Local Impact Report

A47 / A11 Thickthorn Junction – submitted Development
Consent Order Application

Identification No. TR010037

Evidence by David Cumming
Strategic Transport Team Manager

WORK ORDER 45

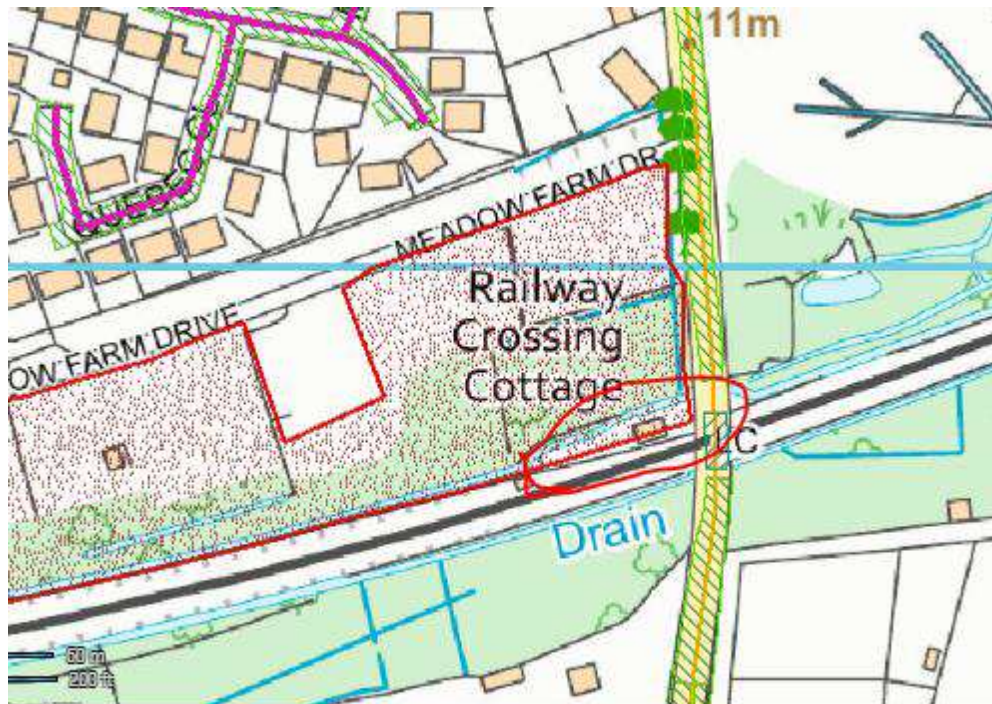
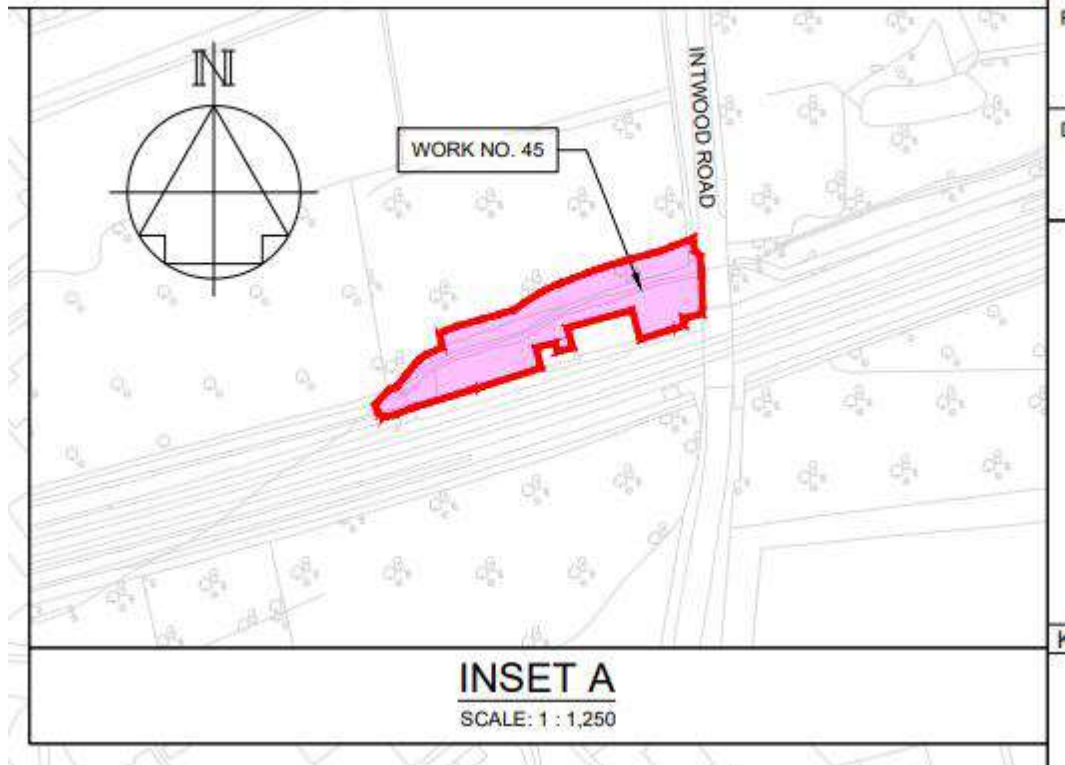
- Work No. 45 (environmental mitigation) is located within Meadow Farm CWS (see below) but this does not appear to have been identified by the applicant. It is not clear what works are planned in this area.

Figure 2b

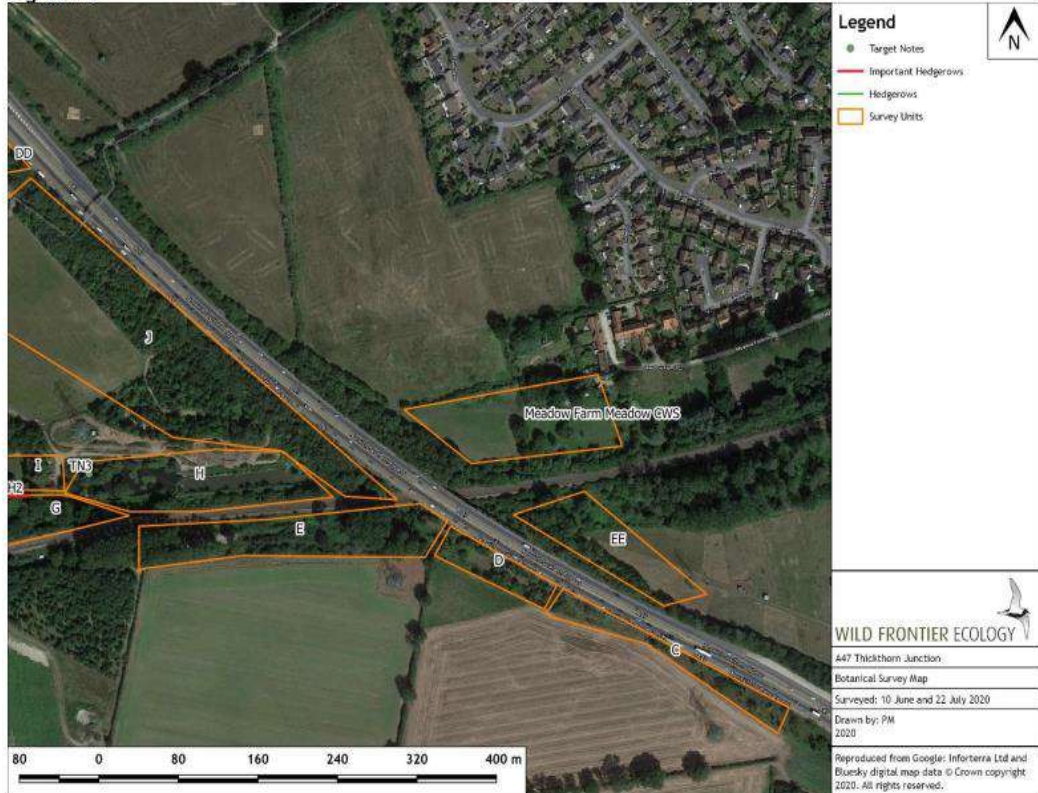
- Work Nos. 6 and 40 may also impact Meadow Farm CWS. Work No 49 abuts Meadow Farm CWS. Work No. 42 directly impacts Meadow Farm CWS and is associated within utilities diversion – it is not clear if this is associated with the UKPN cable route.
- Meadow Farm CWS is only shown to the right of the A47 (top, below). However, it extends to the left of the A47 as shown (bottom, below). This will affect the impact assessment and mitigation requirements.

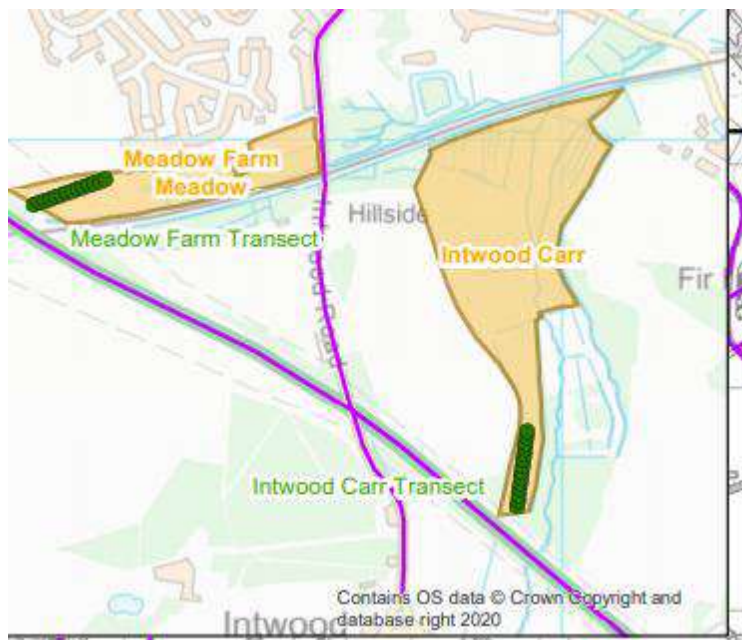
- Para 3.4.8 (below) - It is not clear why reference has been made to Bechstein bats as this species is not present in Norfolk. We (the Natural Environment Team) were consulted in January 2021 with regards to the Long List. During this consultation we queried the use of a 2km CEA ZOI, suggesting the Core Sustenance Zones of bats is used. No mention was made to Bechstein bats.
